Courthouse Square

Re: Recommend approval of Change Order #20

CHANGE ORDER

CHANGE ORDER NUMBER: 20

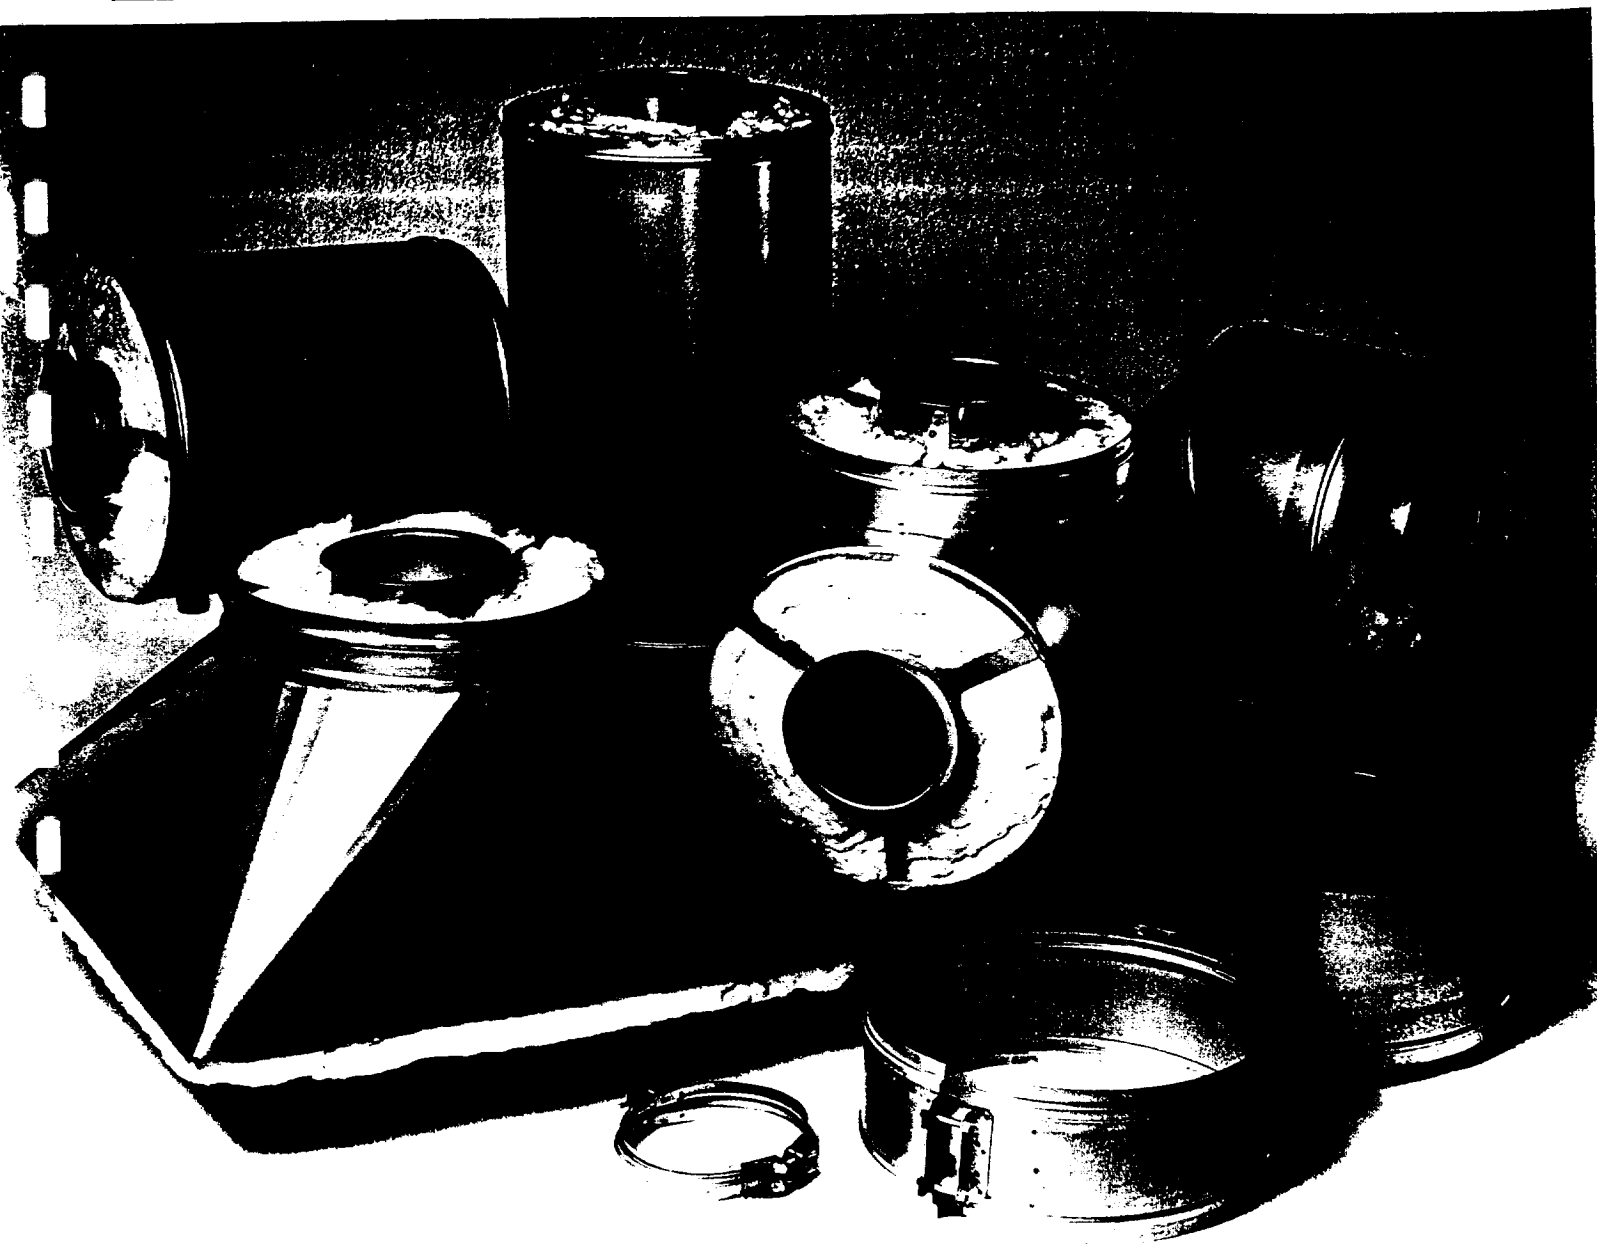
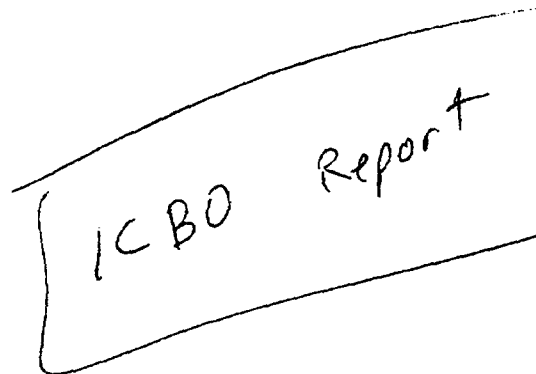
The following is the submittal for review on the grease duct we propose to change to.

It is a copy of my drawing, with some marks on it where the mechanical shaft is.

Note that at the time of this drawing, I was under the mistaken assumption that velocity should be 2500 FPM minimum. This has been corrected, and the actual installation will be 20" diameter. Revised drawings are in process.

Subject: Detail 5/A2.8.1 modification

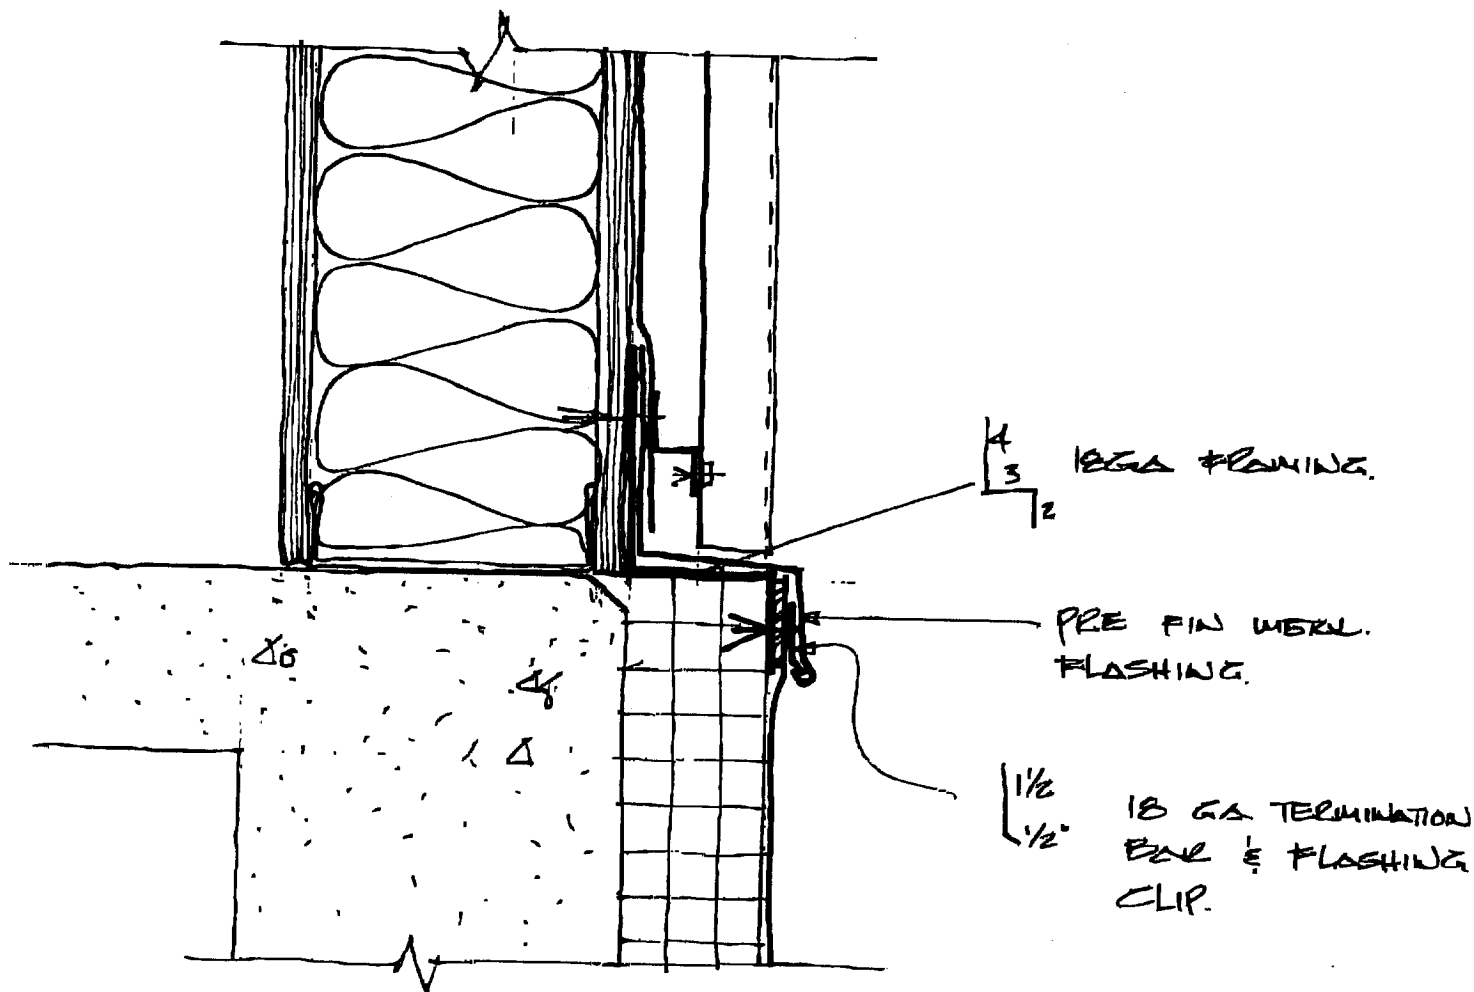
Per meeting with Leonard Lodder, Steve Schaad and the Umpqua Roofing, detail 5/A2.8.2 will be modified along with RFI #401. Please provide the modified detail.

ADD 4x3x2 @ 12 GA. METAL FRAMING @
